SUBJECT: LM-A Preliminary Design Review
Case 620

DATE: October 21, 1968

MEMORANDUM FOR FILE

PURIST MK UATA
FIG. 1

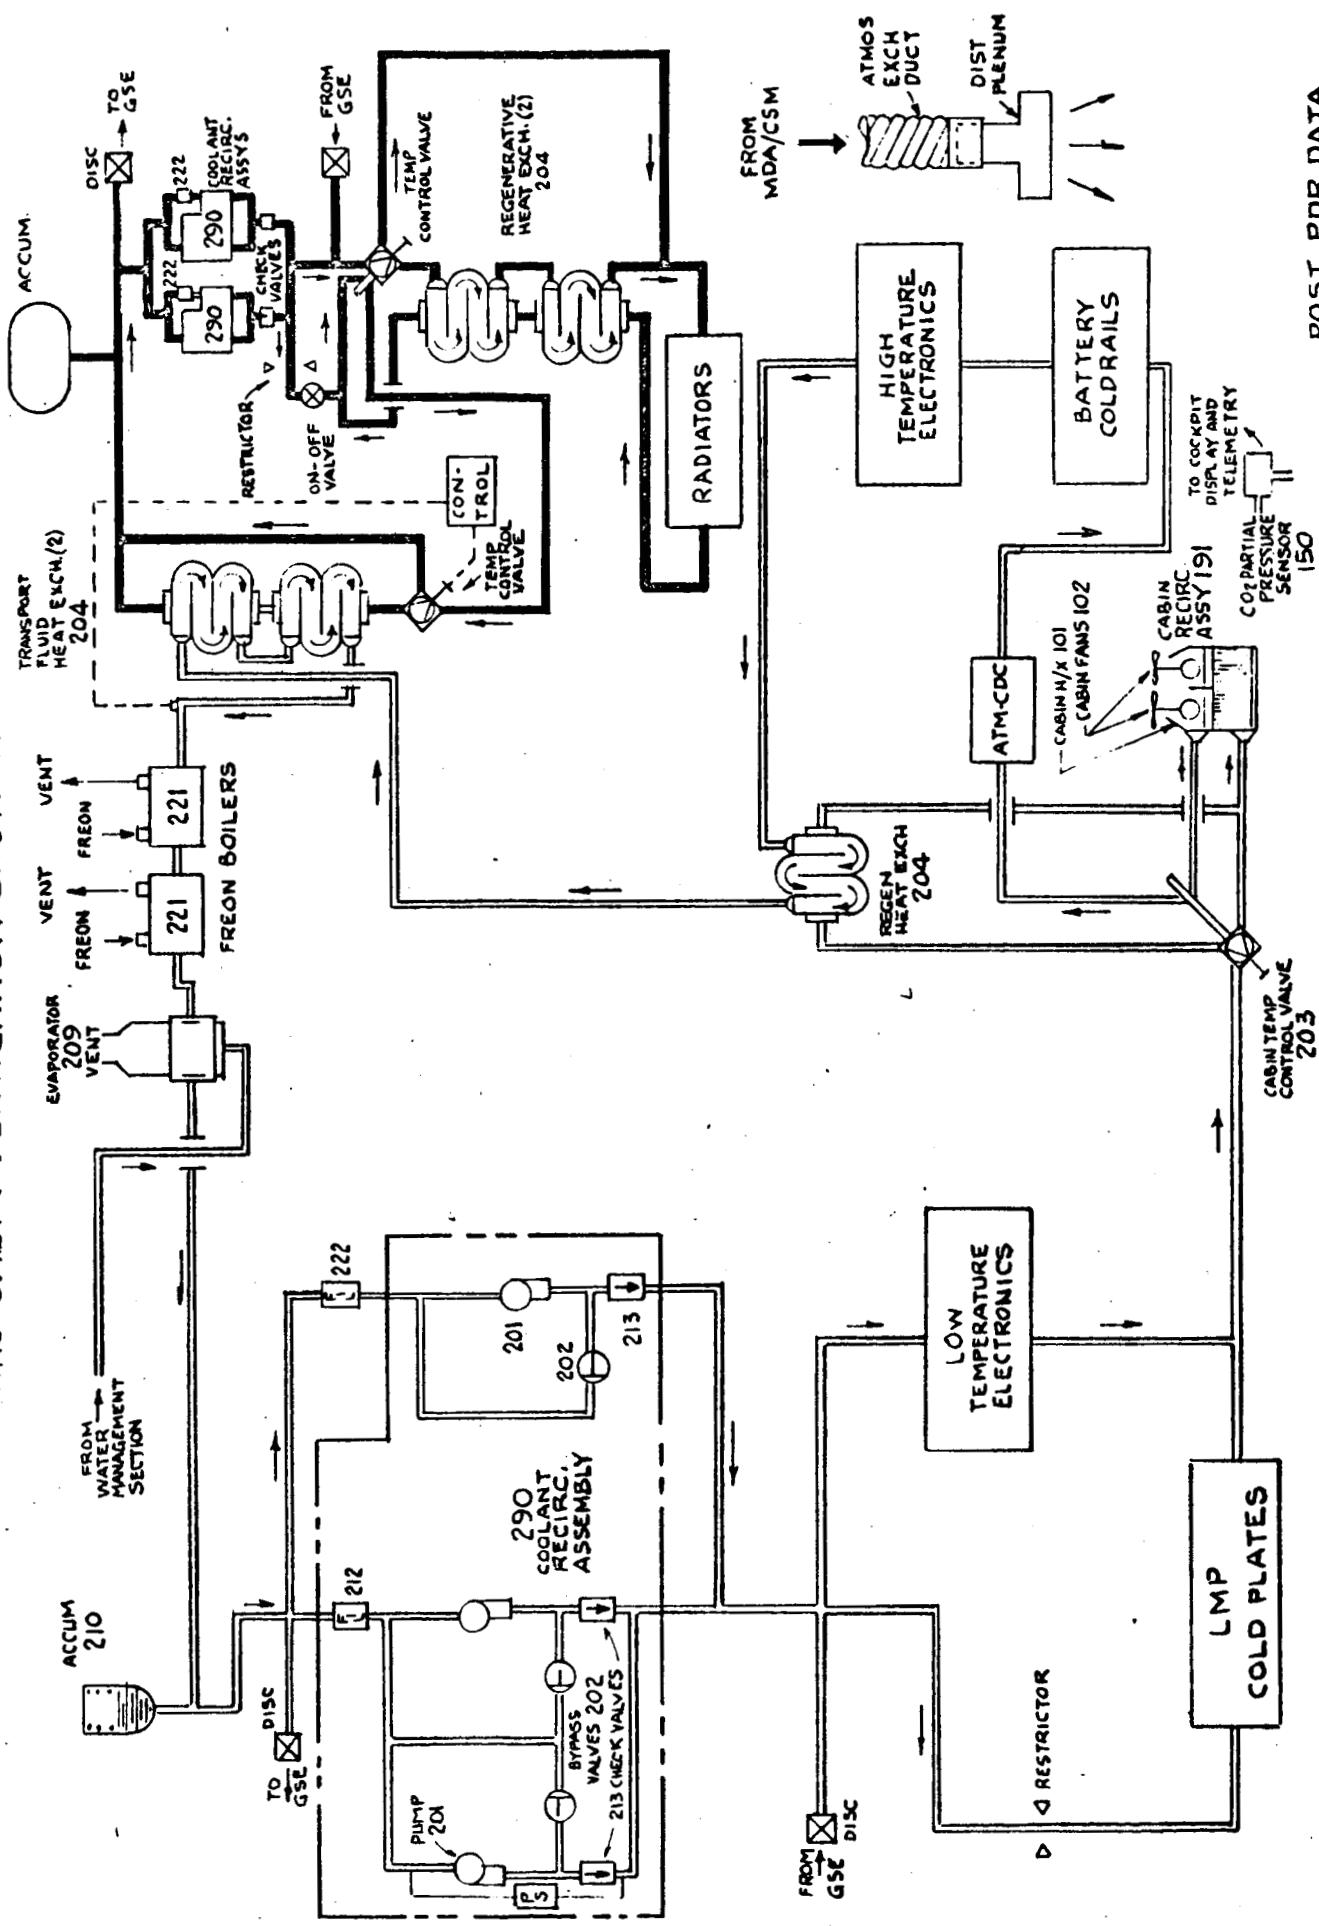
A schematic of the LM-A OSCP GS is given in Figure 1.

- (a) Increase the CM to LM-A O_2 transfer rate from 15 lbs/hr to 19.4 lbs/hr. A higher transfer rate will reduce cabin repressurization time and permit increased flow for EVA.

- (b) Provide redundant pressure control lines from the reference pressure source assembly to the water pressure regulators; make the reference pressure source assembly relief valve redundant. These changes should decrease the possibility of reference pressure loss to the water pressure regulators.

- (c) Install an O_2 filter in the accumulator - regulator path; use filters with pressure relief by-pass features for non-redundant paths.
- (d) Equip the O_2 pre-breathing stations with disconnects and flow limiters as provided in the O_2 umbilical supply; install a redundant O_2 pressure regulator assembly. These changes will provide a redundant O_2 supply for EVA.

- (e) Reduce the docked interface leak rate from 0.1 lb/hr. to 0.05 lb/hr. MSC feels that NR data supports a lower leak rate.

FIG. 3

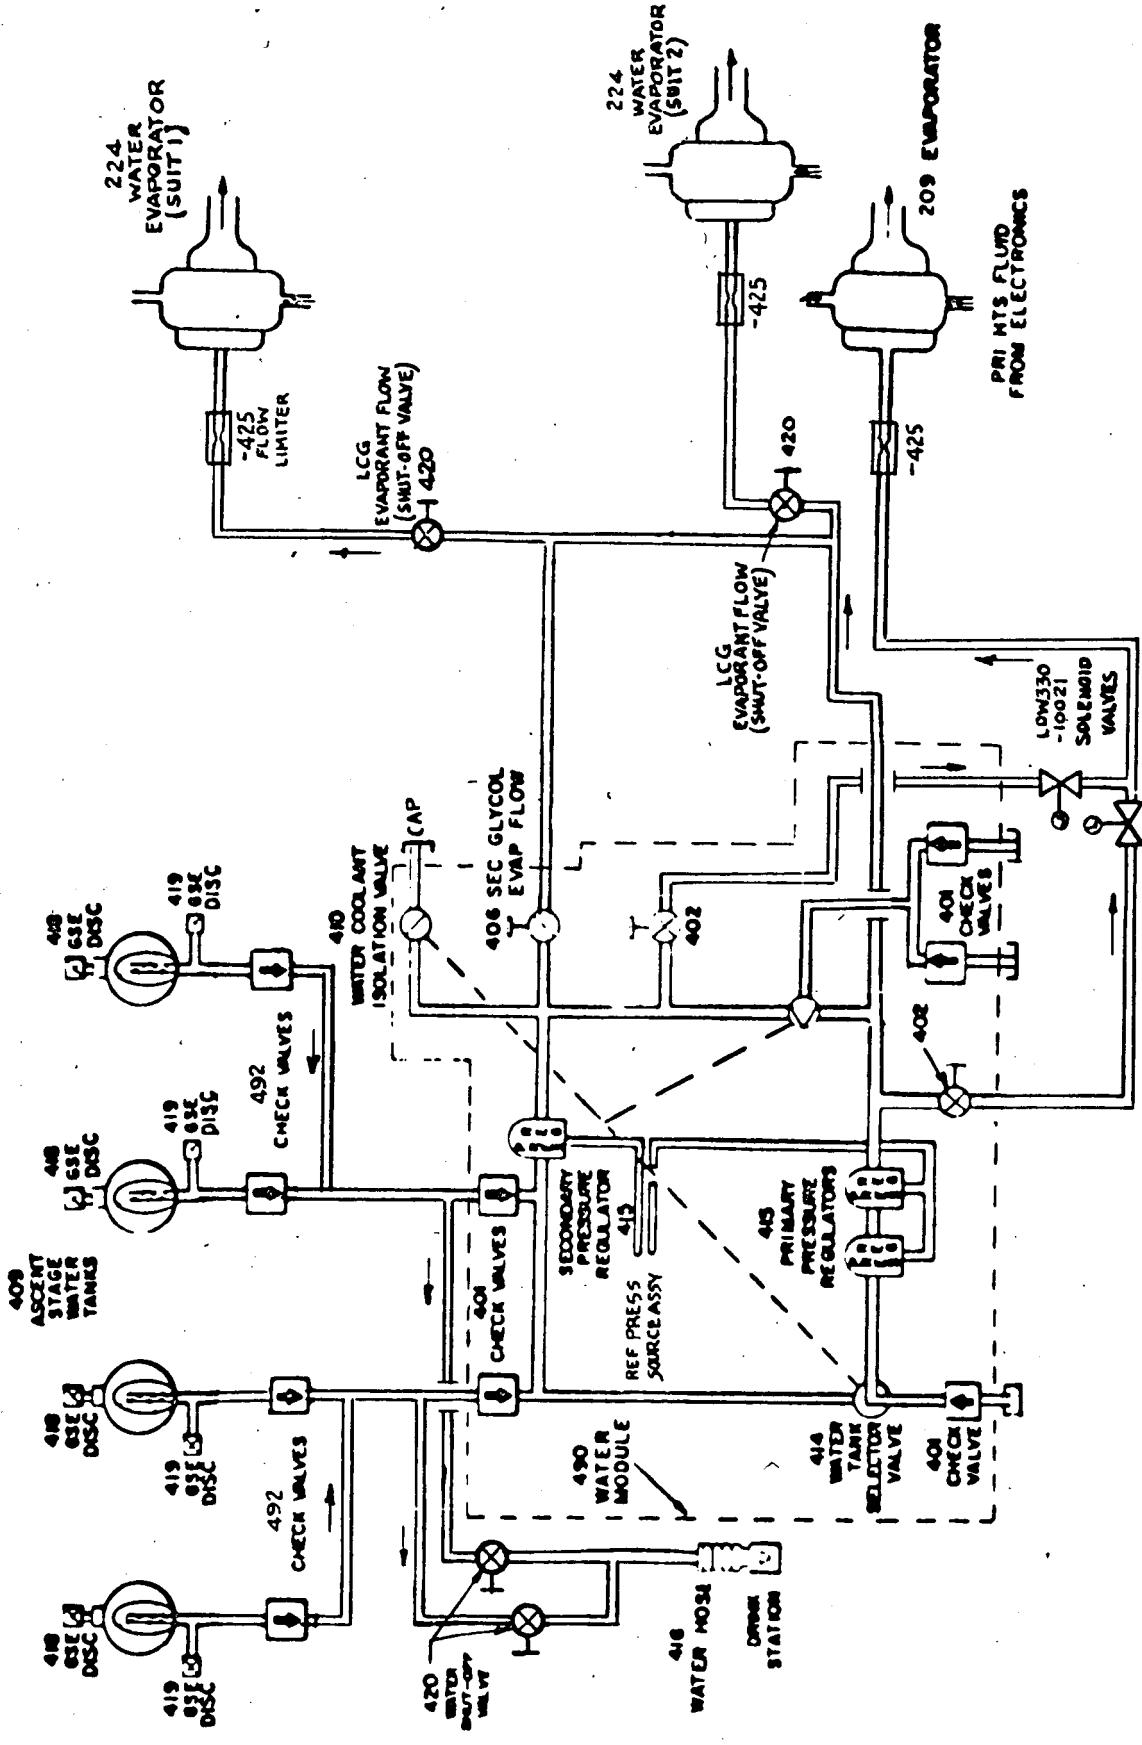
The post-PDR WMS schematic is given in Figure 3.

- (a) Recharge capability from the CM is to be provided which will reduce the required number of water tanks from 4 to 3.
- (b) The 490 water module is retained from the LM. Suggestions were made to redesign the module to avoid several compromises and to provide increased redundancy and reliability.

FIG. 4

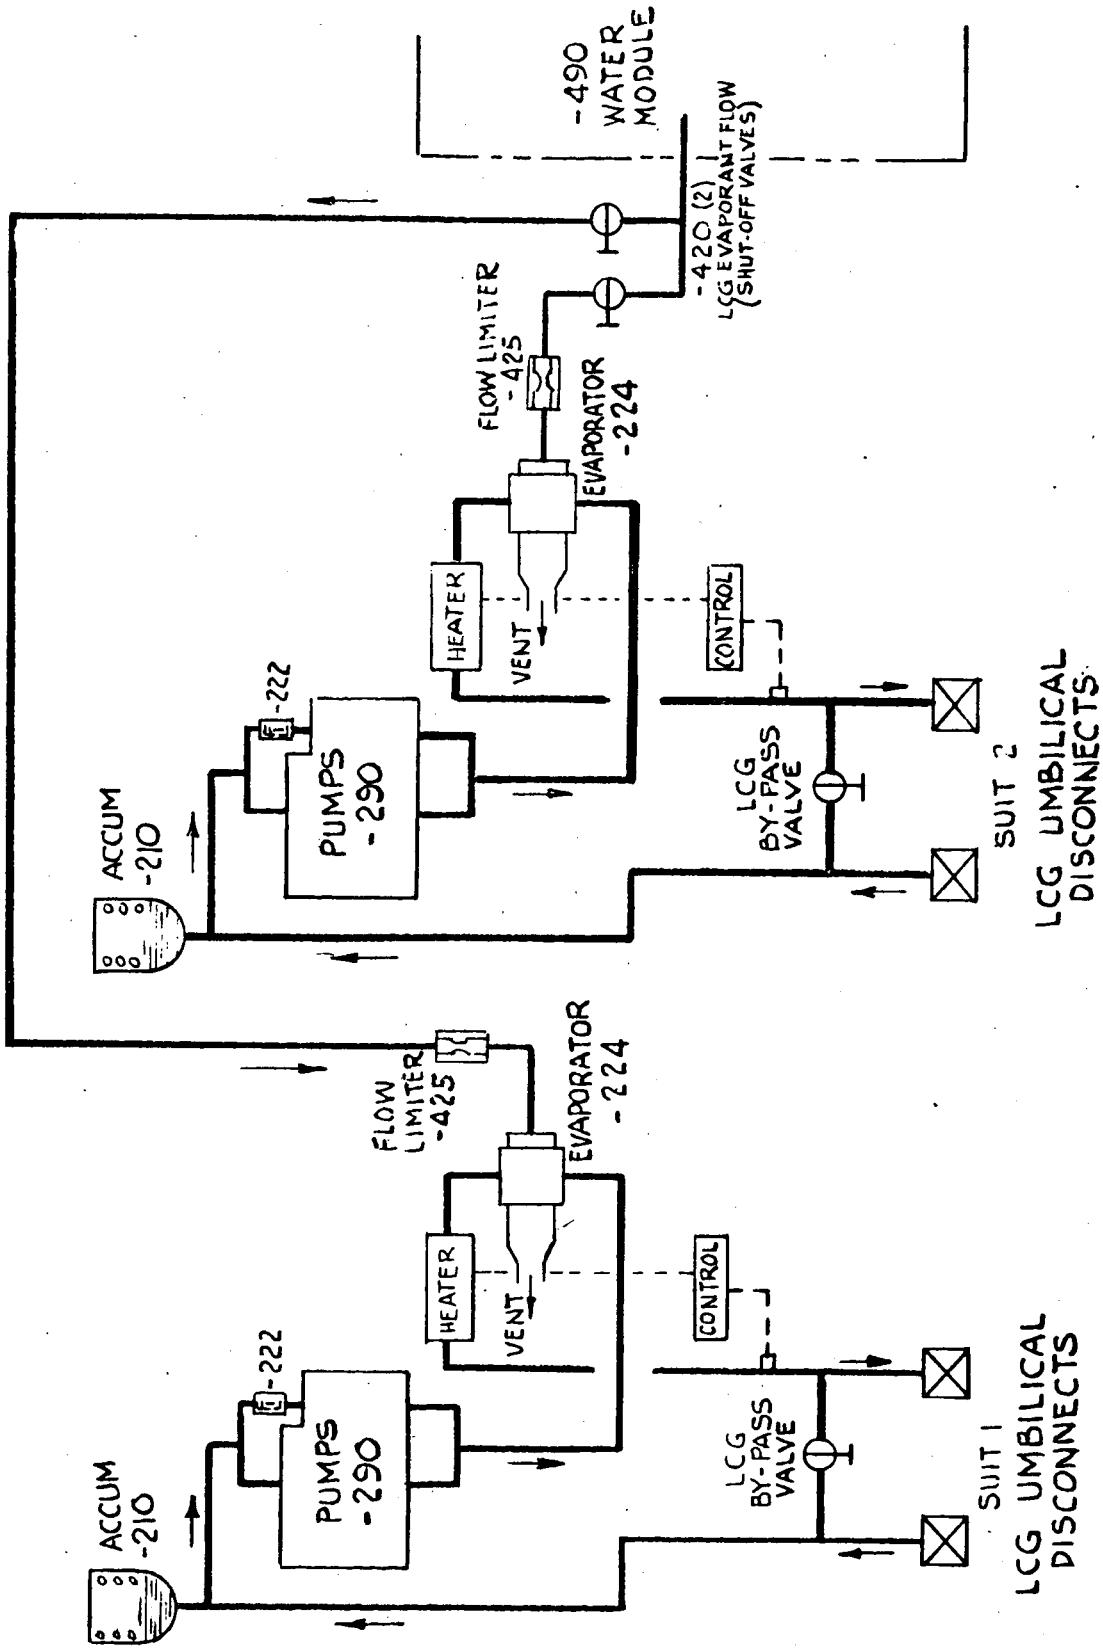
The post-PDR LCGSS schematic is attached, Figure 4.

- (a) A number of questions were raised as to the heat rejection adequacy of the LCGSS. The present evaporator (type 224) will reject 2000 BTU/hr at an outlet temperature of 45°F and a coolant flow rate of 230 lbs/hr. A RID was submitted to provide 2500 BTU/hr cooling at the same outlet temperature and flow rate.
- (b) Additional RID's are:
 - provide automatic switching from pump 1 to pump 2 in both pump assemblies;
 - provide duplicate, parallel umbilical inlet and outlet water disconnects to each pump-sublimator loop;
 - equip each inlet and outlet umbilical path with shut-off valves;
 - replace the present sublimators and associated equipment with CM type water boilers and associated equipment.
- (c) The heaters in each loop have 125 watts capacity, maintain the minimum loop temperature at 40°F, and require approximately 3/4 hour to dry out the sublimator.
